**Official Transcript of Proceedings**  
**NUCLEAR REGULATORY COMMISSION**

Title:                   Advisory Committee on Reactor Safeguards  
                              Thermal Hydraulic Phenomena Subcommittee

Date:                    Tuesday, May 5, 2020

4 The focus of my 30-plus years of  
5 experience has been nuclear fuel design and  
6 performance, poor reload safety analyses, and plant  
7 operations. Today, I will be presenting Reg Guide  
8 1.236 which provides guidance for evaluating a nuclear  
9 reactor's initial response to a postulated control rod  
10 ejection or control rod drop accident. So let's  
11 begin.

Figure 1. High-Temperature Cladding Failure Threshold

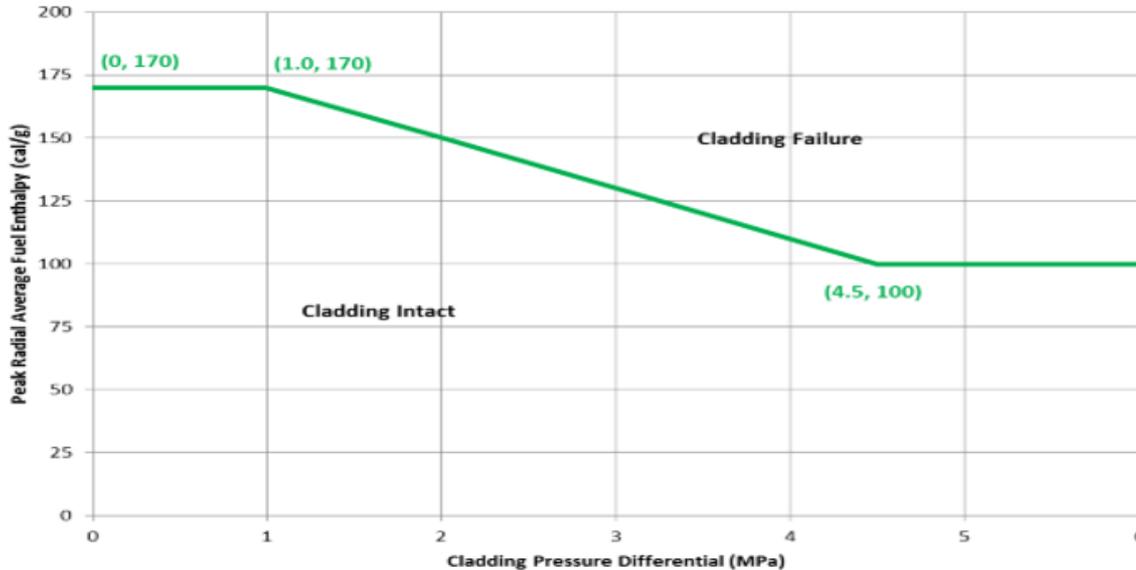
15 Based upon comments received, the  
16 application of the high temperature cladding failure  
17 curve which we just talked about was changed from all  
18 zero power scenarios to all prompt critical power  
19 scenarios to be more consistent with the empirical  
20 database. So the way this is now worded was if you're  
21 at prompt critical excursion, you use Figure 1. If  
22 you're non-prompt, then you use your DNB, CPR thermal  
23 design limits to estimate cladding failure. Any  
24 questions?

Figure 3. PCMI Cladding Failure Threshold—SRA Cladding at or above 500 Degrees F

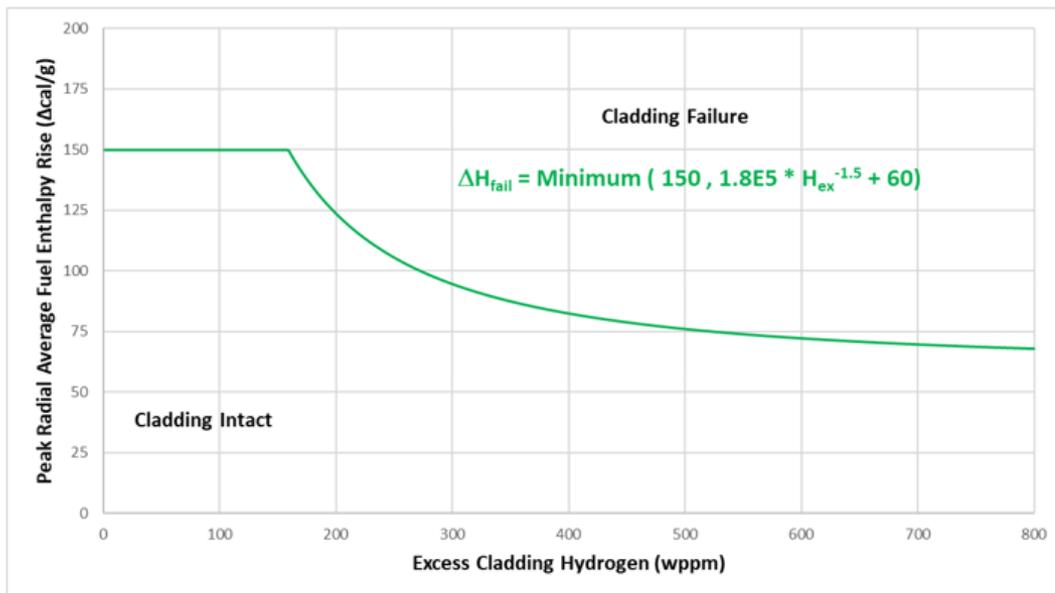
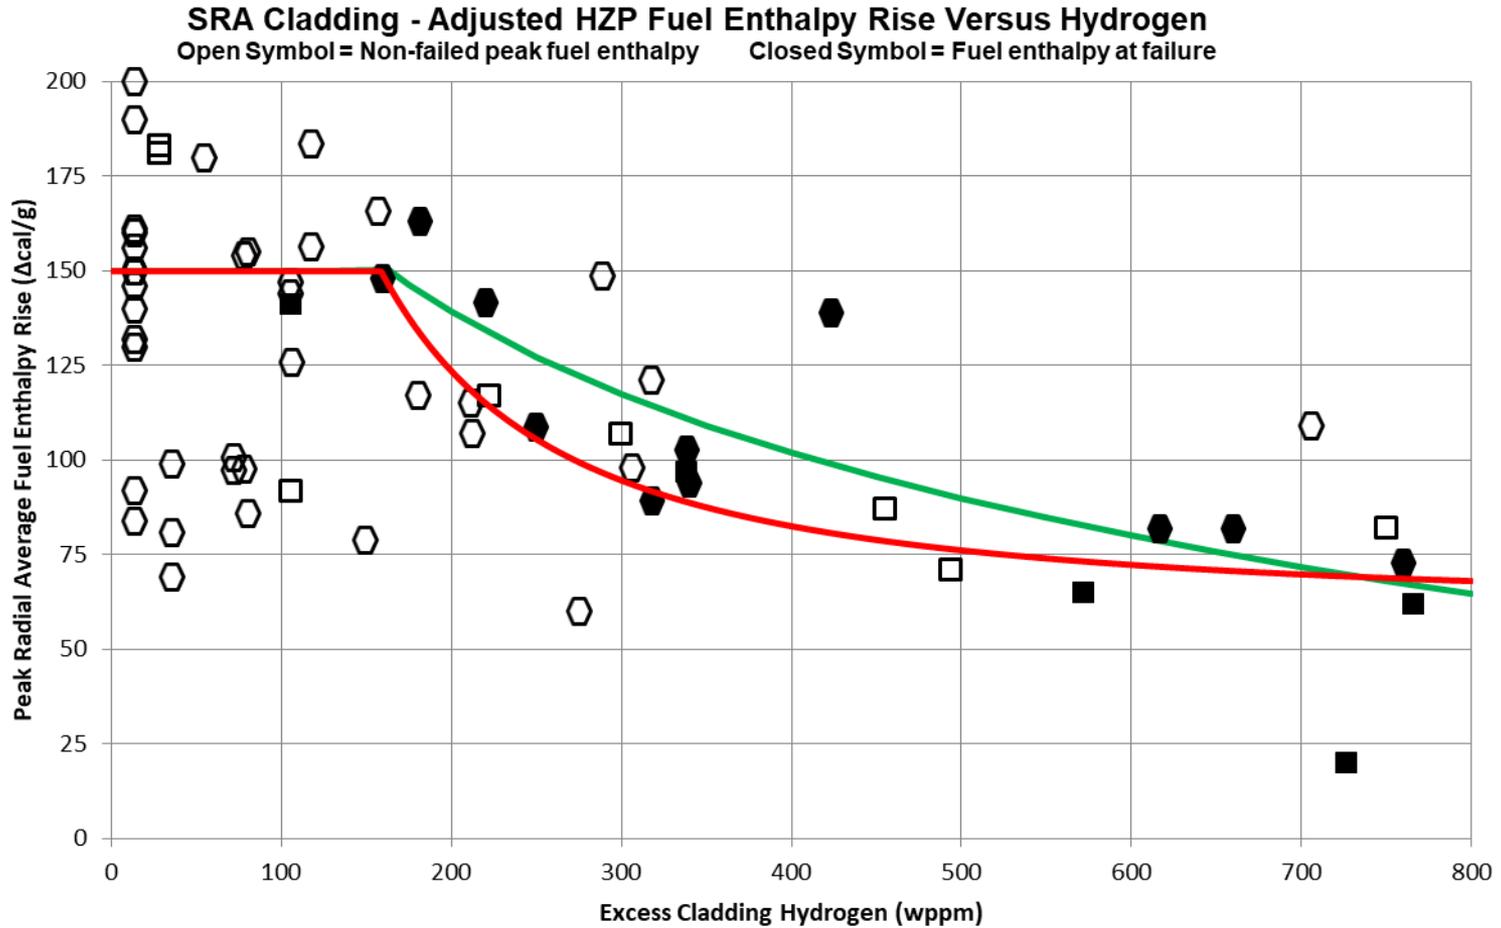
6 So let's get into a comparison of these  
7 four curves. This plot shows the SRA high temperature  
8 cladding failure from the DG-1327 along with a revised  
9 curve from Reg Guide 1.236 and the supporting  
10 database. In response to comments, the algebraic form  
11 of the failure correlation was changed. The new  
12 correlation exhibits a steeper decline showing a  
13 higher sensitivity to initial hydrogen content but  
14 then a saturation effect.

15 To provide regulatory stability, the staff  
16 elected to use a more conservative fit as opposed to  
17 the prior best estimate fit of the failure data. Best  
18 estimate curves are susceptible to constant change as  
19 new data becomes available. And as we started in  
20 2007, as more data became available, the staff found  
21 themselves redrawing the curves, trying to reestablish  
22 a best estimate fit.

7           There are certain points on the curve  
8 which I show that were considered to be faulted either  
9 due to there was an incident where one of the more  
10 recent tests, the water was initially water-logged  
11 which meant it had failed before the event occurred.  
12 So the results aren't really applicable. And some of  
13 the earlier CAPRI tests had a lot of spallation and  
14 hence hydride lenses on the cladding which would fail  
15 at a much lower enthalpy and aren't allowed by the  
16 current design of fuel. So we didn't intend to bound  
17 all the data. We just bounded most of the data.

# Impact of Barrier Liner

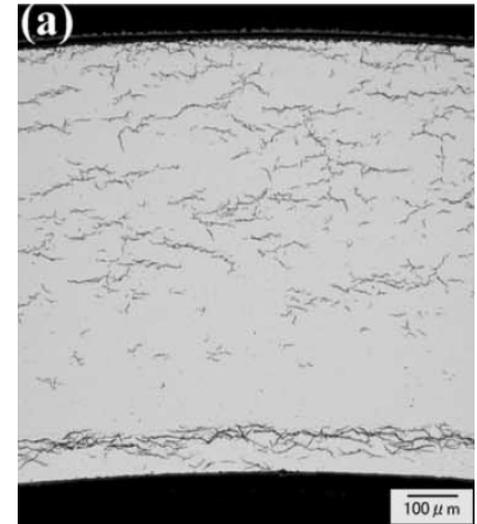
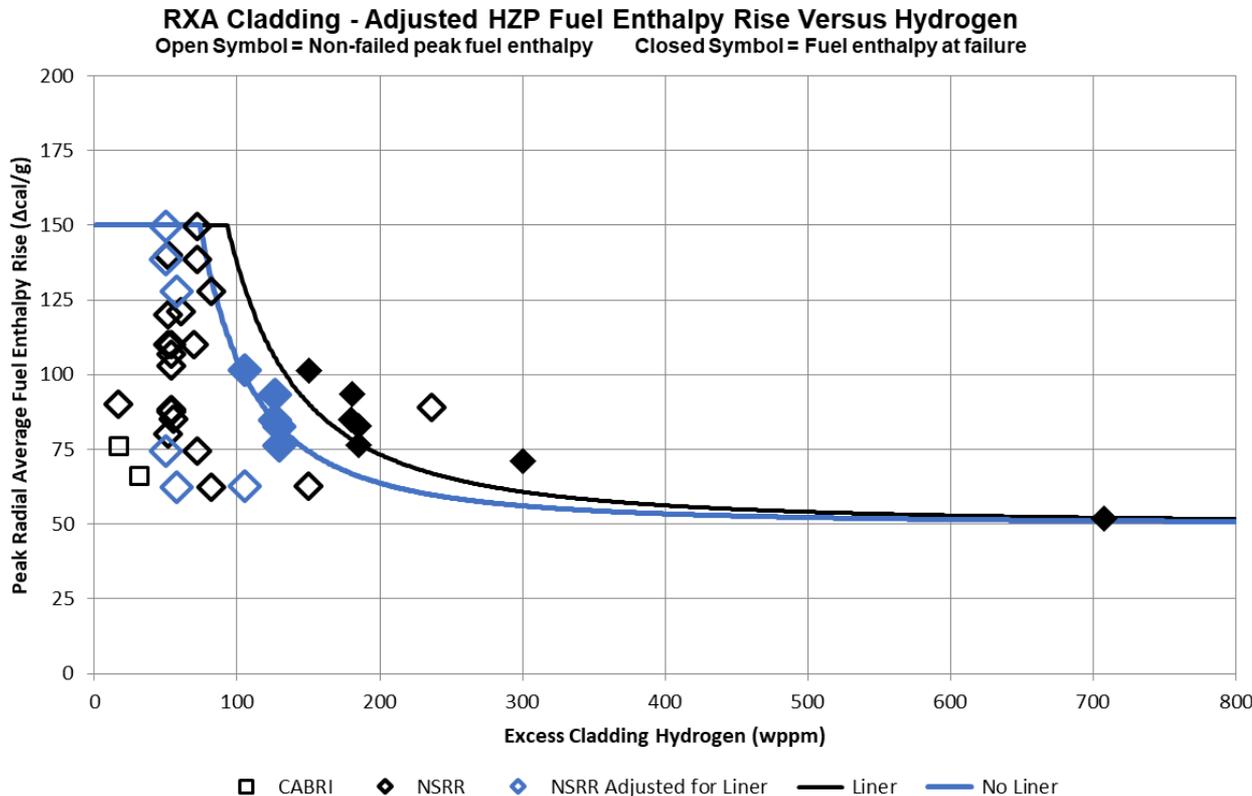
19 So maybe we move on to -- also, we're  
20 sticking with PCMI but moving into a different topic.  
21 We're getting into the impact or the potential impact  
22 of barrier lining on the application of PCMI failure  
23 thresholds. So in response to numerous fuel rod  
24 failures during normal operation in the BWR fleet in  
25 the '70s and '80s, the industry developed barrier

16 And if plants were to move away from  
17 zirconium liner, then they wouldn't have that second  
18 benefit, and thus at the same excess hydrogen level  
19 would have a higher impact on the cladding ductility,  
20 hence the shift in the curve. Okay. We'll go to the  
21 next slide. Now we're getting into a different agenda  
22 topic which is the hydrogen models.
